SUPPLIER DOCUMENT COVER SHEET**Syncrude Canada Ltd.****WorleyParsons**
resources & energy**Worley – Syncrude Projects Group**

Supplier Name:	PENTICTON FOUNDRY LTD.
Client Contract No.:	4410322556
Purchase Order Description:	HCWI Spools
Supplier Document Title:	Preliminary Detailed Fabrication Drawings and Bill of Materials

SUPPLIER DOCUMENT TITLE: Preliminary Detailed Fabrication Drawings and Bill of Materials**VENDOR DOCUMENT REVIEW**

R = 4064

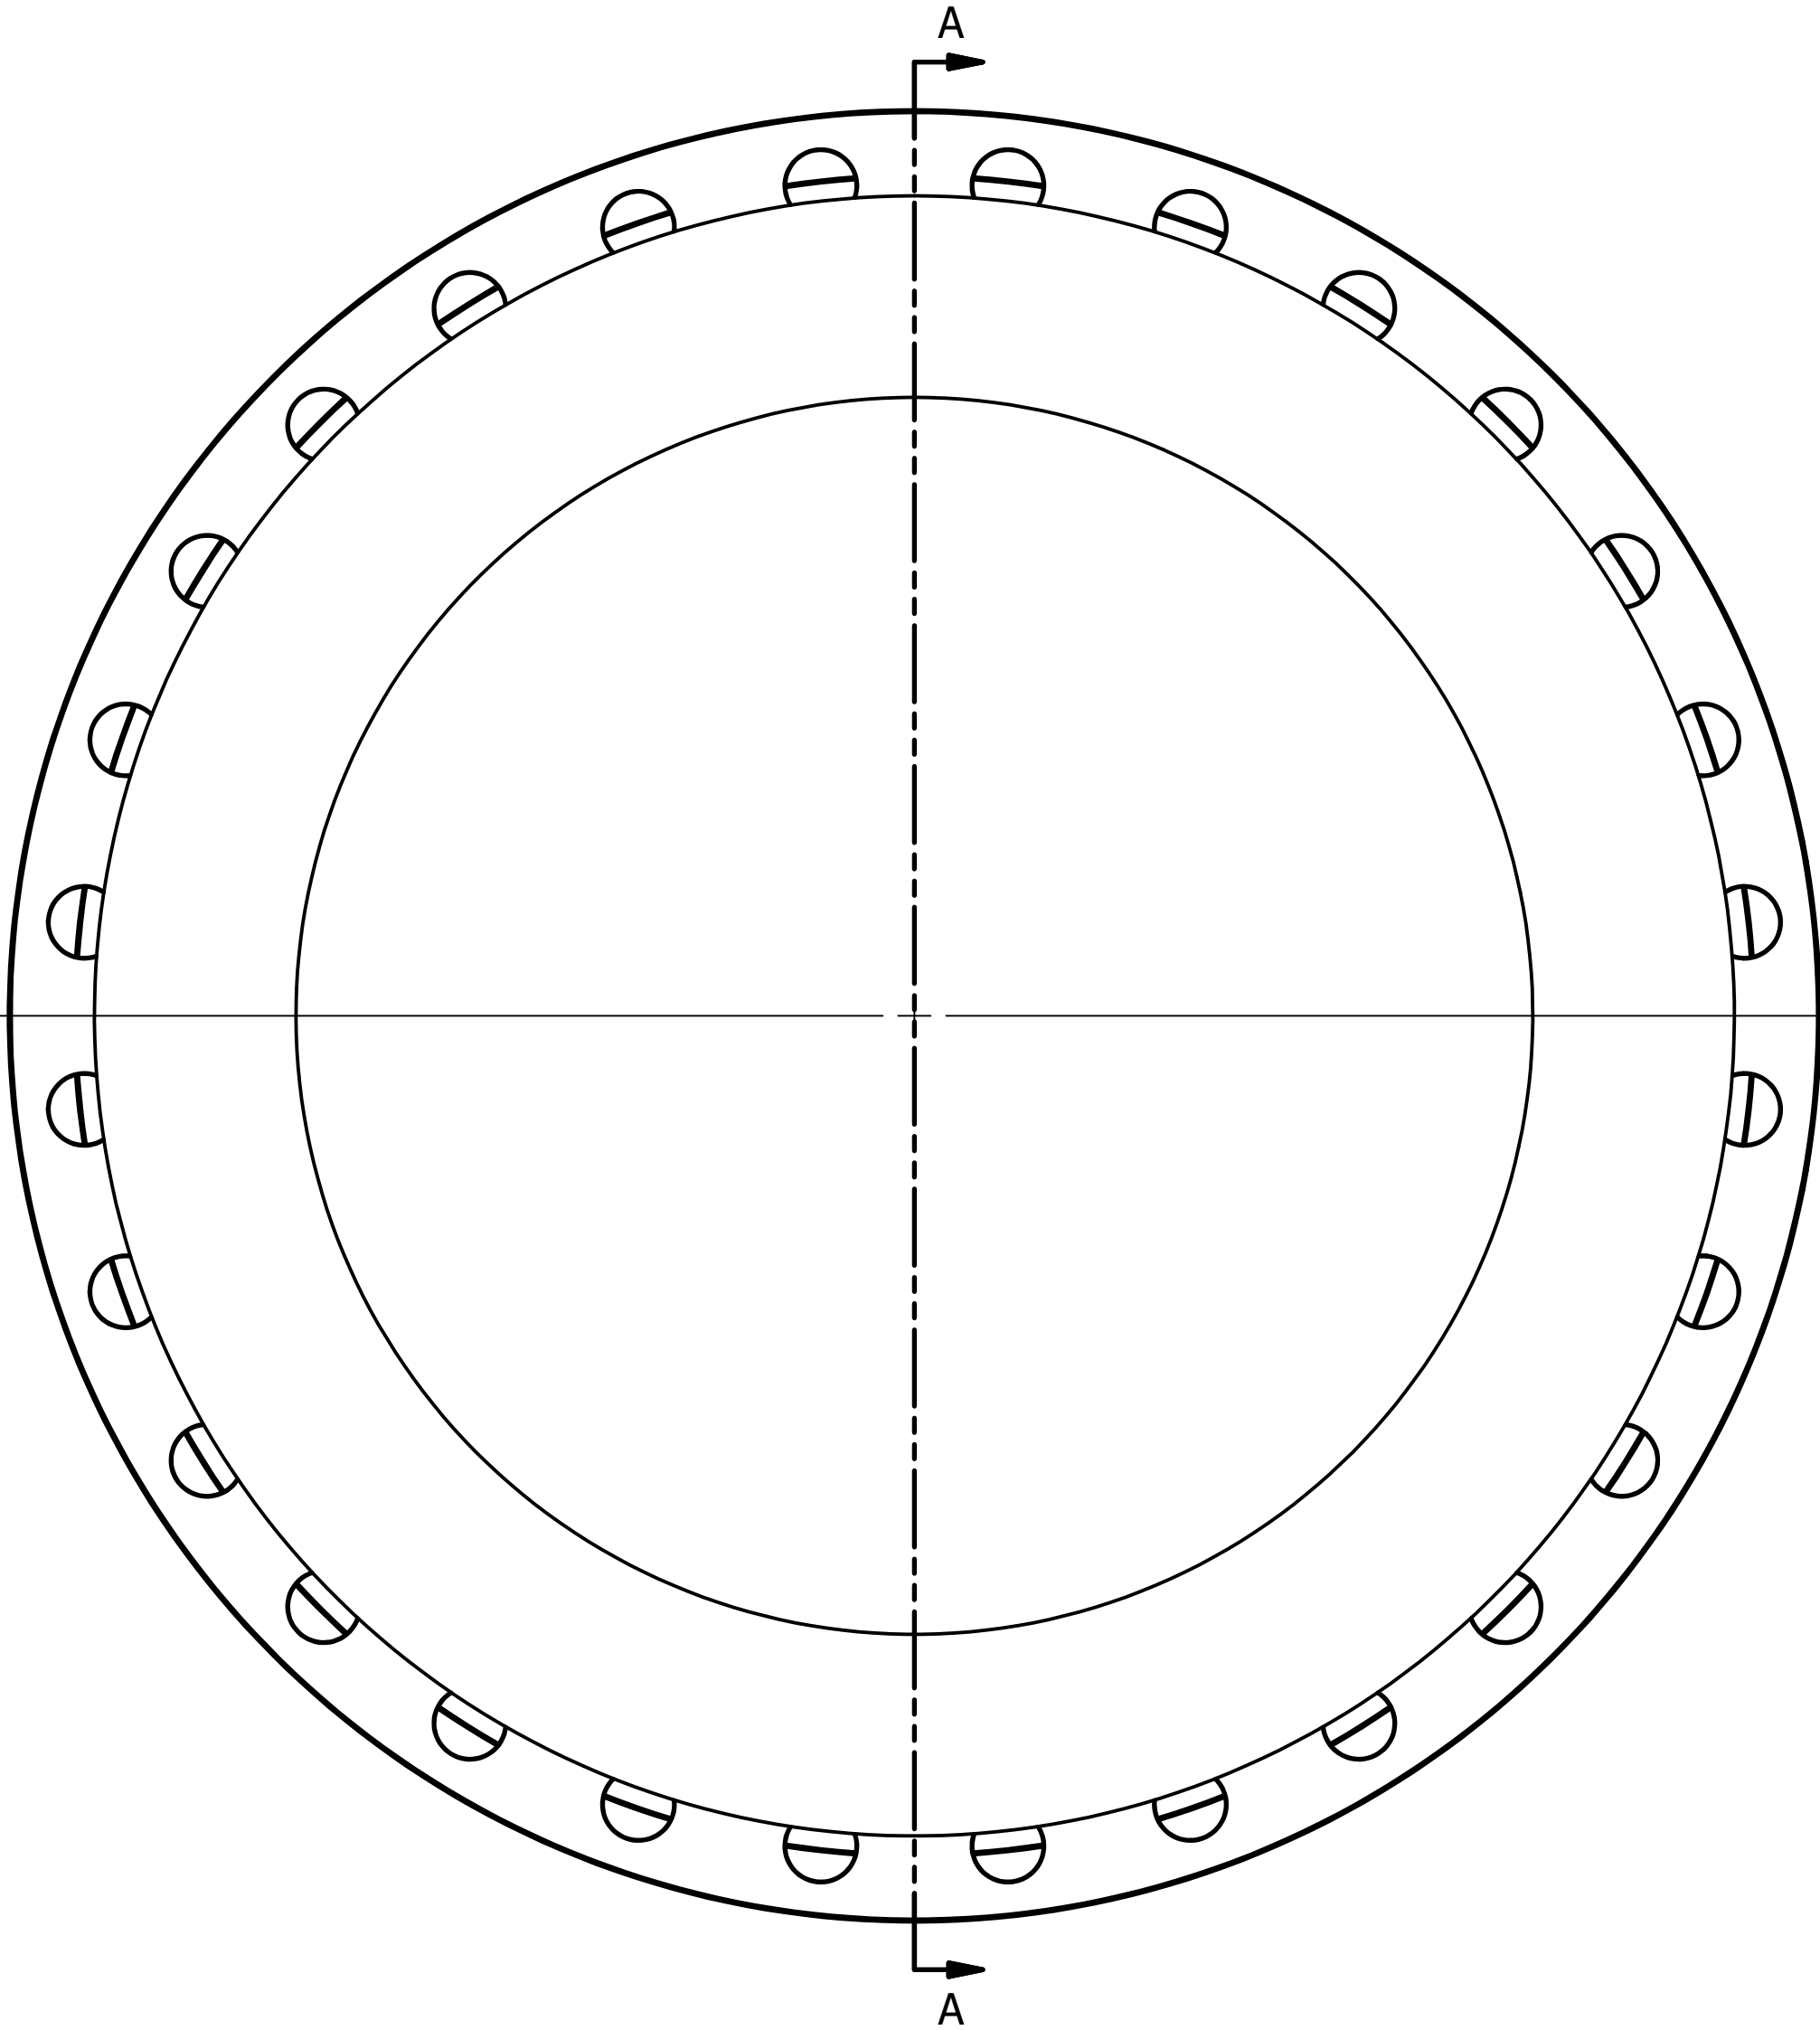
Refer to comments on individual spool sketches

A1-19027-400-00 Spool SP-237-002-P-002-1-C sketch
ESTIMATED WEIGHT: 8,070 lbs. (3,665 kg)

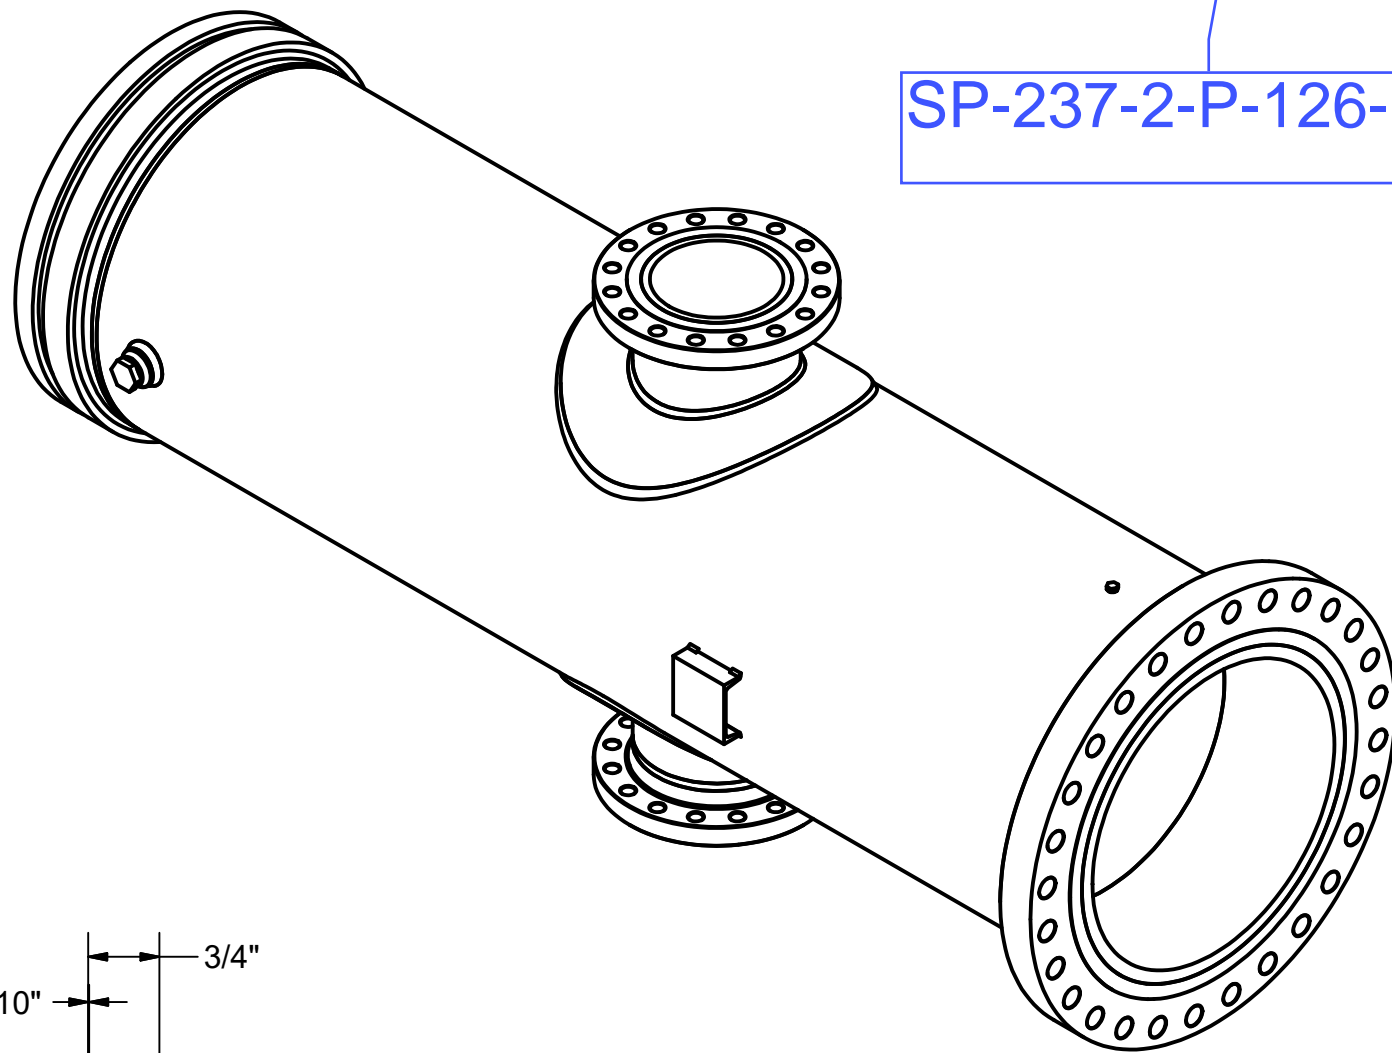
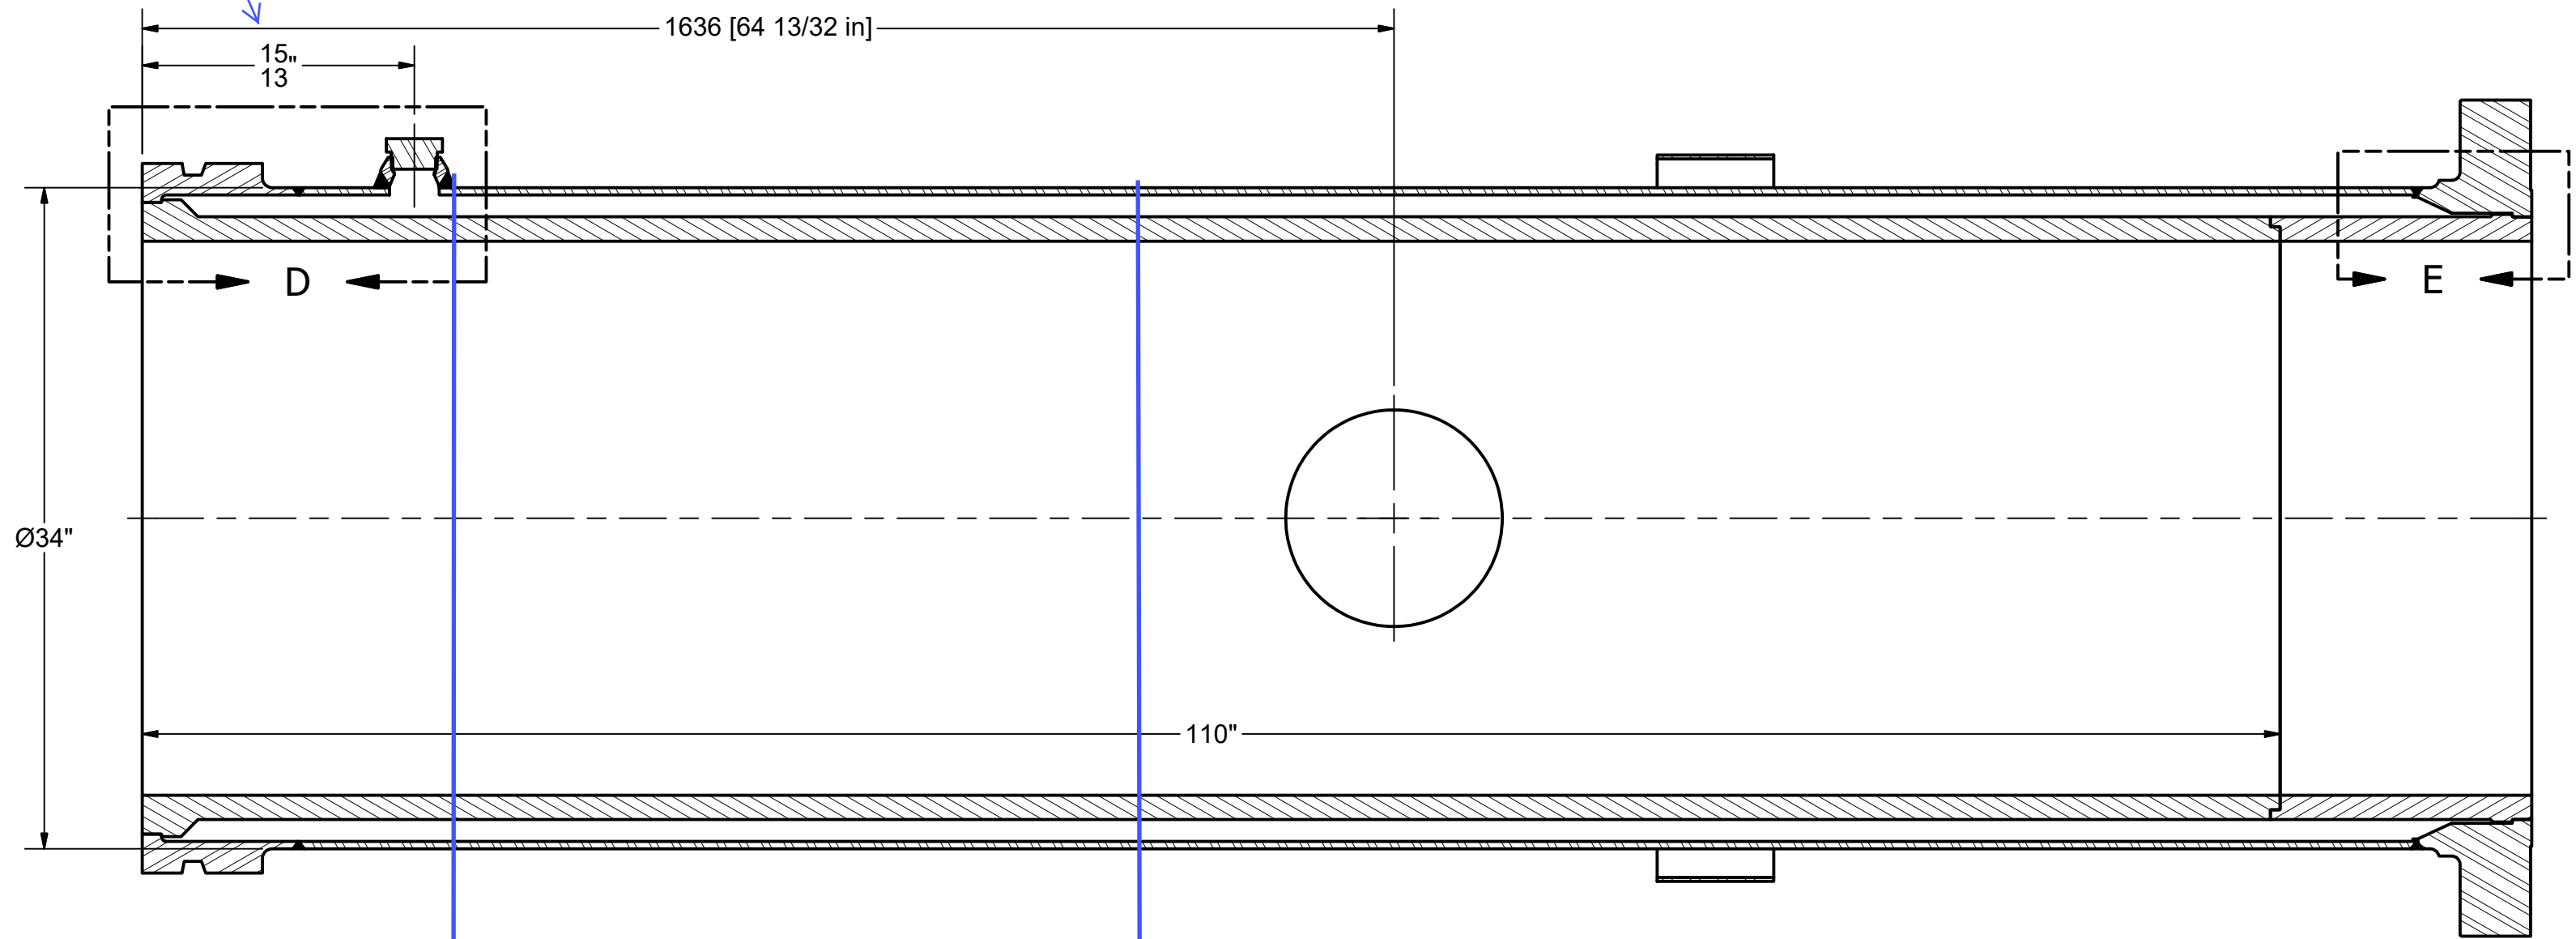
15" OR 13"?

DETAIL F

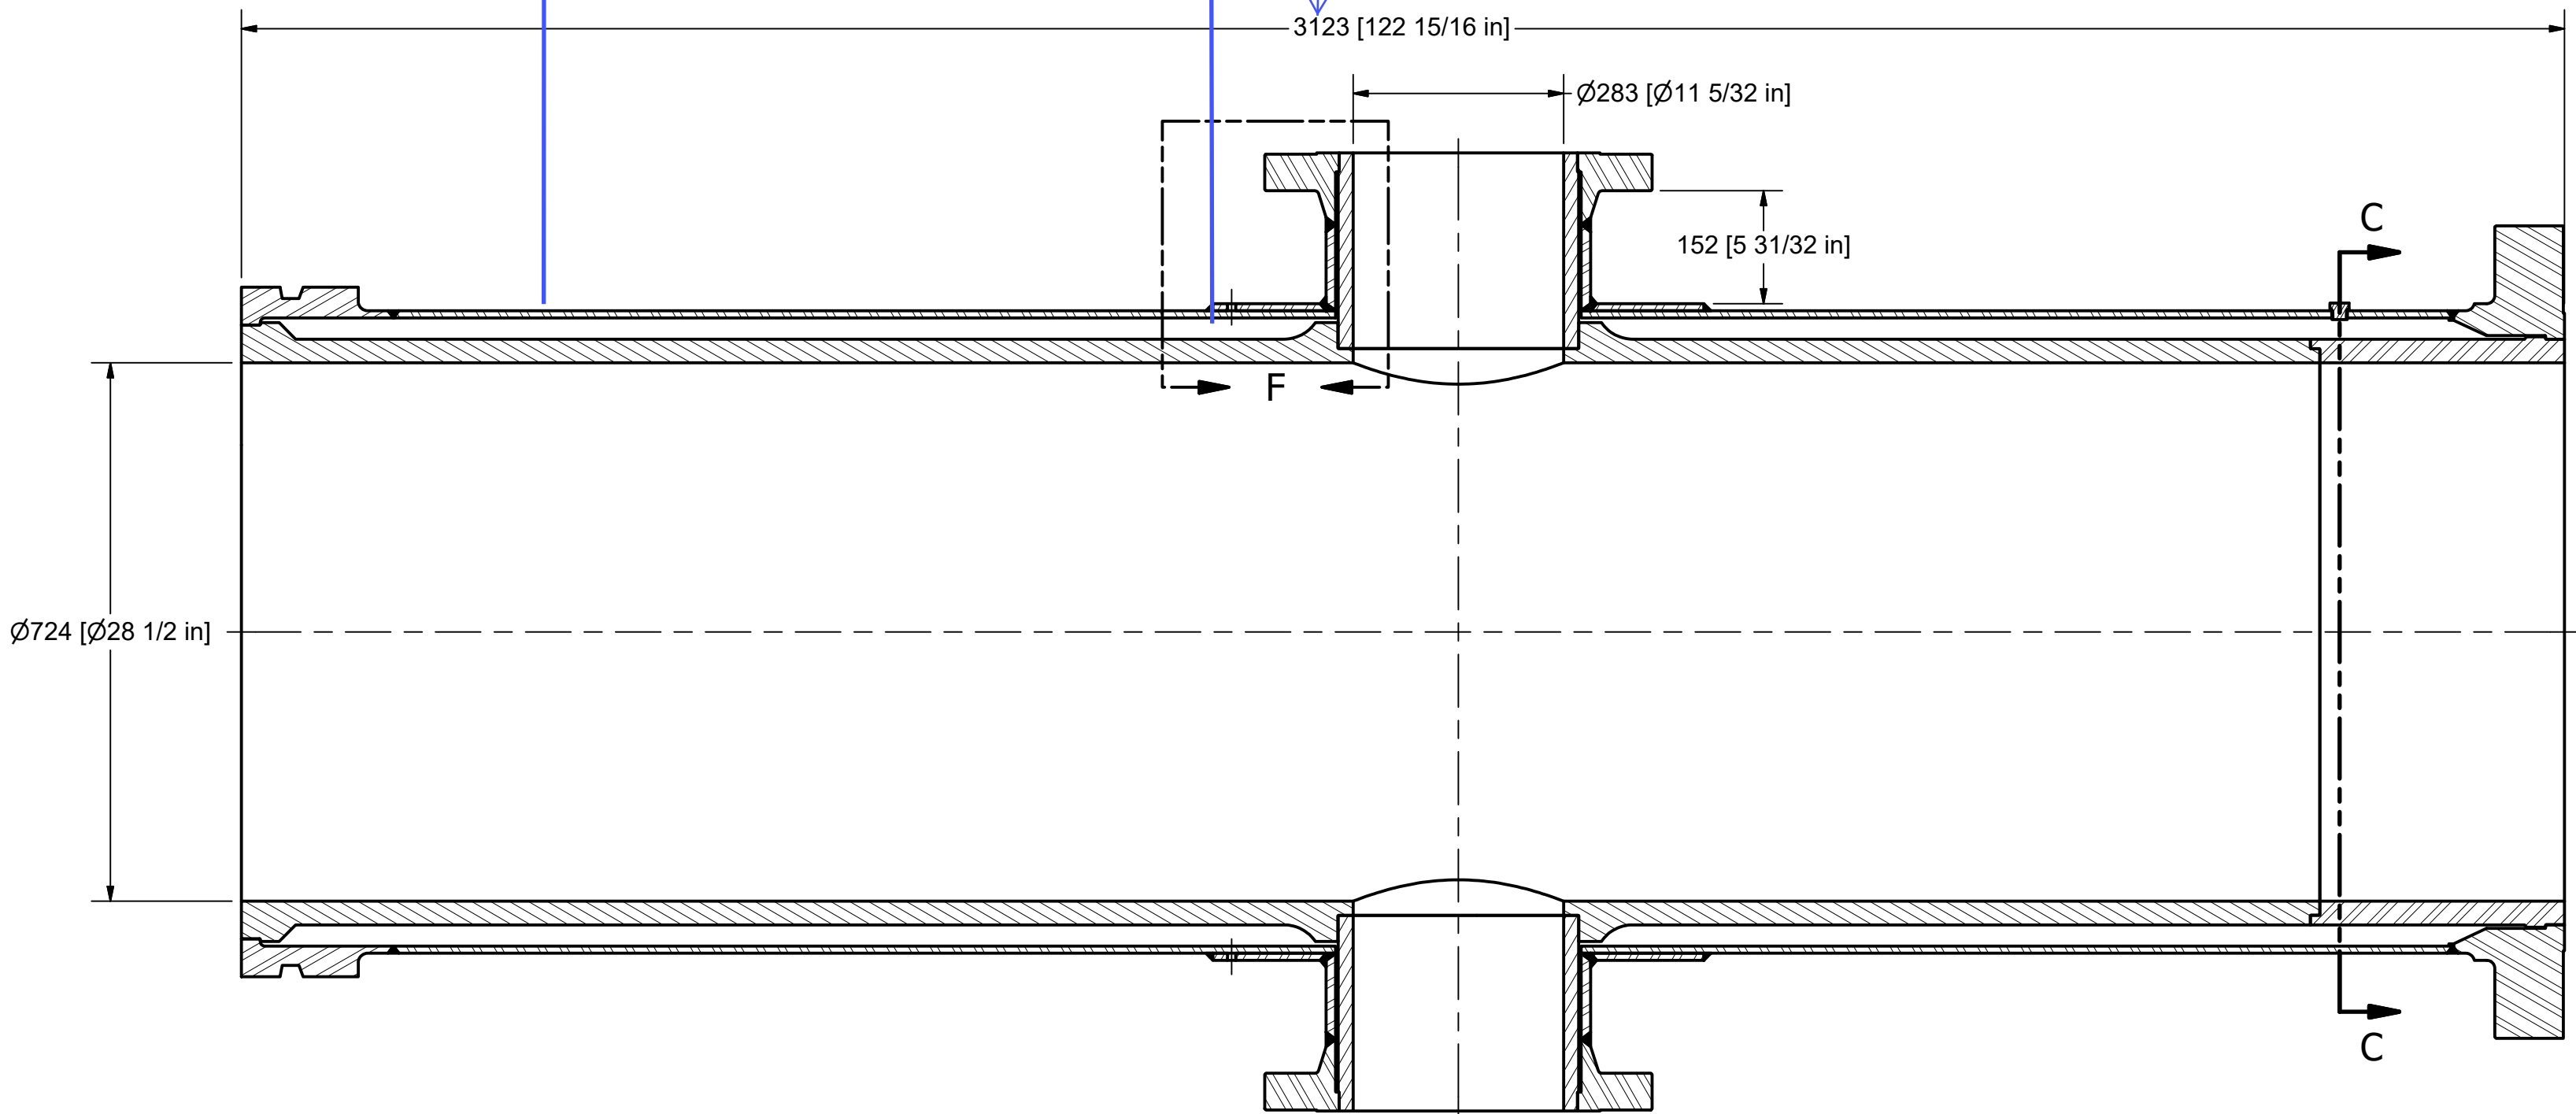
?

SECTION C-C

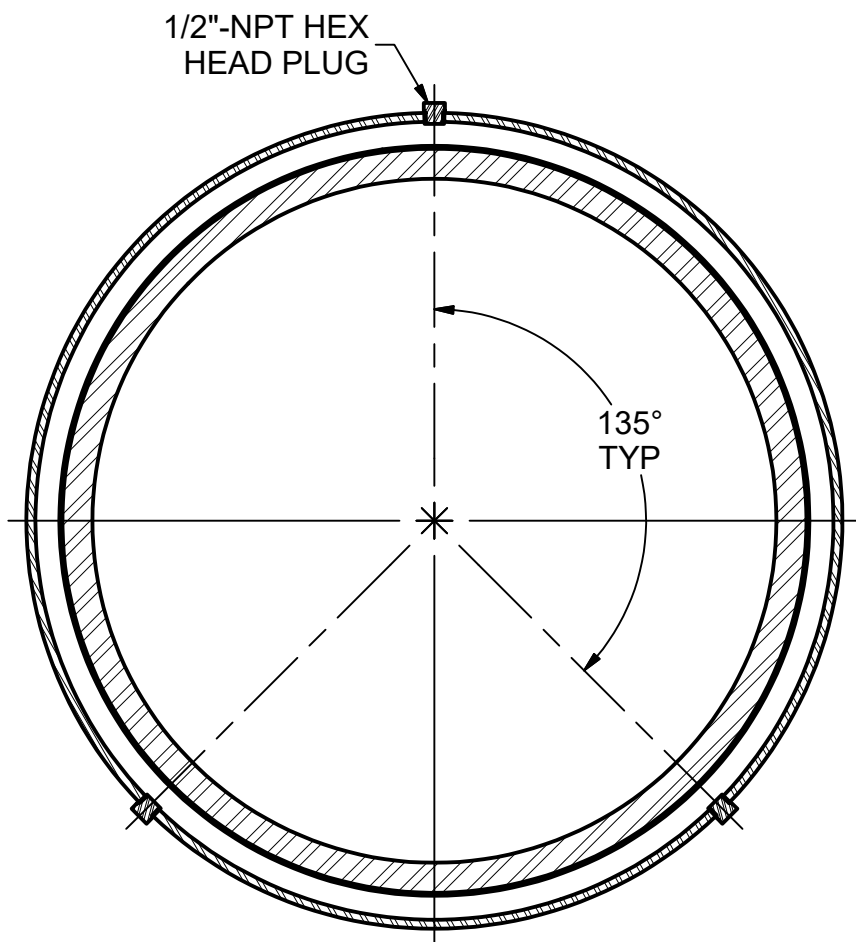
PIPE SIZE?
